Access Compliance Report

Public Rights-of-Way

Intersection ID: 8204	Main Street: BEATTIES_FORD_RD	Cross Street: CATHERINE_SIMMONS_AV	Location: SE
ADA ID: B4E1763F4B7C	Ramp Type: PerpDiag	Initial Pass/Fail: Fail	Overall Compliance: No
Severity Score: 30			
Codes/Mitigation Info/Possible Solution		Field Measurements/Component Compliance

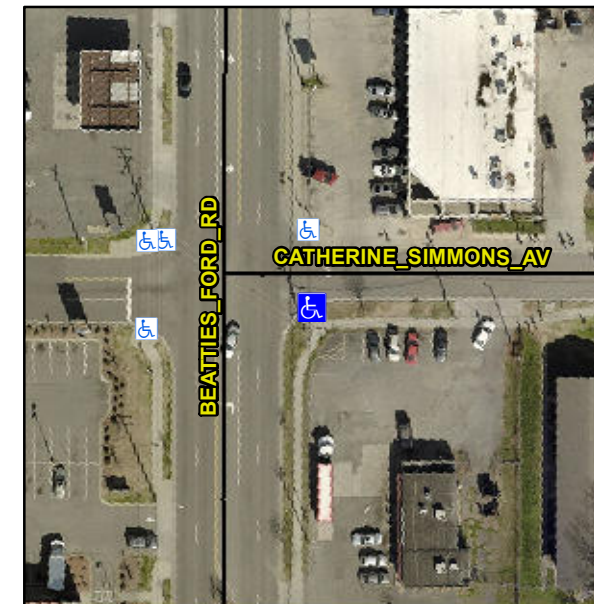
Not Found, R304.5.1, R304.5.3

Compliance	Description	Data	Compliance	Description	Data
N/A	Ramp Length (in)	107.0	Yes	Ramp Slope (%)	8.1
No	Ramp Width (in)	35.5	No	Ramp XSlope (%)	5.7
N/A	Flare Type LT	N/A	N/A	Flare Type RT	N/A
N/A	Flare Slope LT (%)	N/A	N/A	Flare Slope RT (%)	N/A
N/A	Flare Traversable LT?	N/A	N/A	Flare Traversable RT?	N/A
N/A	Landing Length (in)	N/A	N/A	DWS Provided?	N/A
N/A	Landing Width (in)	N/A	N/A	DWS Contrast?	N/A
N/A	Landing Slope (%)	N/A	N/A	DWS Length (in)	N/A
N/A	Landing X Slope (%)	N/A	N/A	DWS Full Width?	N/A
N/A	Landing Curb? (Y/N)	N/A	N/A	DWS Offset (in)	N/A
N/A	Shared Landing?	N/A			
N/A	Gutter Ponding?	N/A	N/A	Gutter Slope (%)	N/A
N/A	Gutter Lip Ht (in)	N/A	N/A	Gutter X Slope (%)	N/A
N/A	Painted X Walk1?	No	N/A	Painted X Walk2?	No
	X Walk 1 Direction	To N		X Walk 2 Direction	To W
N/A	X Walk 1 Width (in)	N/A	N/A	X Walk 2 Width (in)	N/A
	X Walk 1 Slope (%)	2.5		X Walk 2 Slope (%)	0.9
	X Walk 1 X Slope (%)	1.3		X Walk 2 X Slope (%)	0.1

Remove & Replace Curb Ramp With Two New Directional Ramps or Equivalent.
